Sub: Modification sheet no. RDSO/2025/EL/MS/0508, Rev. '0' dated 23.04.2025 for provision of Waterless Urinal in WAP-7 Three Phase Electric Locomotives.

Modification Sheet No. RDSO/2025/EL/MS/0508, Rev. '0' Dated: 23.04.2025

Provision of Waterless Urinal in WAP-7 Three Phase Electric Locomotives.

3. Modified Arrangement:

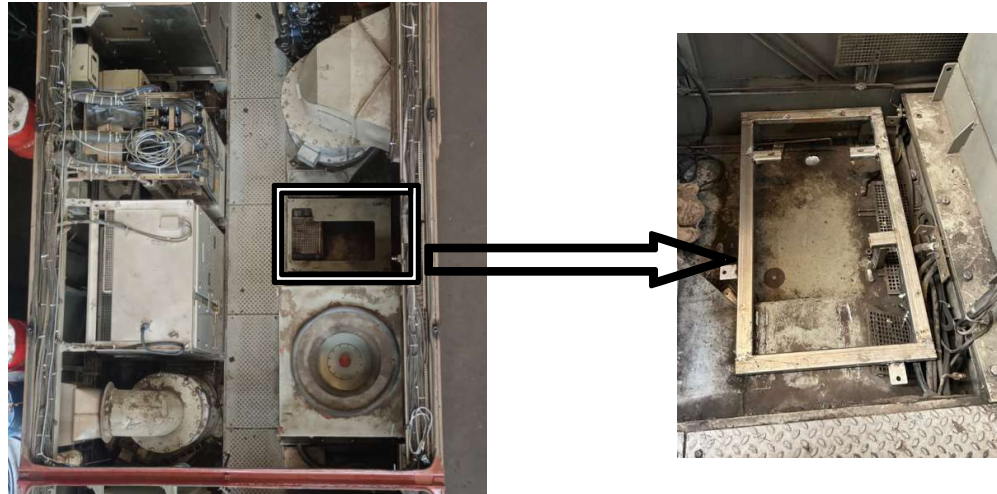
The Waterless Urinal in WAG-9HC locomotives are being provided in the space available near Cab-1 (LHS). Since there is no such required space (1050 L X 600 W X 1830 H) available in WAP-7 locomotives. Waterless urinal shall be installed at the space vacated by harmonic filter as per RDSO Modification Sheet No. RDSO/2024/EL/MS/0504, Rev. 1 dated 23.04.2025.

This scheme shall be applicable to those locomotives where Harmonic Filter can be removed as per RDSO Modification Sheet No. RDSO/2024/EL/MS/0504, Rev. 1 dated 23.04.2025 or latest. Waterless urinal

shall be installed at vacated space on suitable mounting frame after removal of Harmonic Filter as annexure-I.

LAYOUT OF WLU FOR WAP7
IN PLACE OF CUBICAL FILTER
(SCHEME-I)

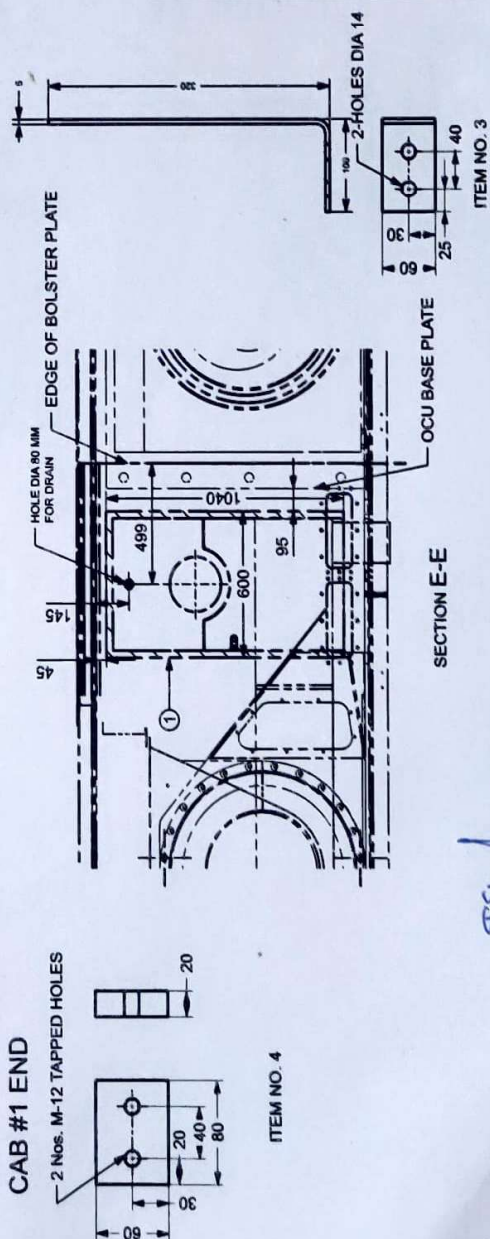
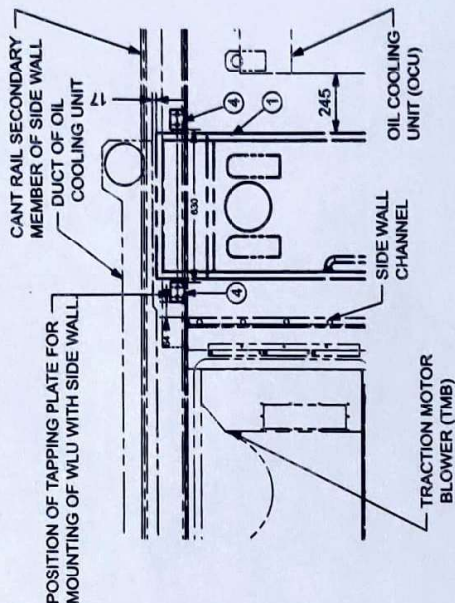
- i. Complete Harmonic filter cubicle shall be removed from the Loco and the Waterless Urinal shall be installed after providing the mounting frame. Shown as given below:

- ii. The Waterless Urinal mounting stand shall be as per drawing attached as annexure-II.
- iii. The design of urinal has been prepared for WAG9 locomotives with maximum permissible height of 1830 mm. However for fitment in WAP7 locomotives as per this modification sheet the vendor supplying urinals with height above 1750 mm will have to shorten the door from bottom by 40 mm and a U channel shall be provided to fit the waterless urinal as per drawing attached as annexure-III.
- iv. The discharge pipe for the waterless urinal shall be fitted beside wheel no. 6. The discharge pipe shall be secured with additional clamps as shown below.
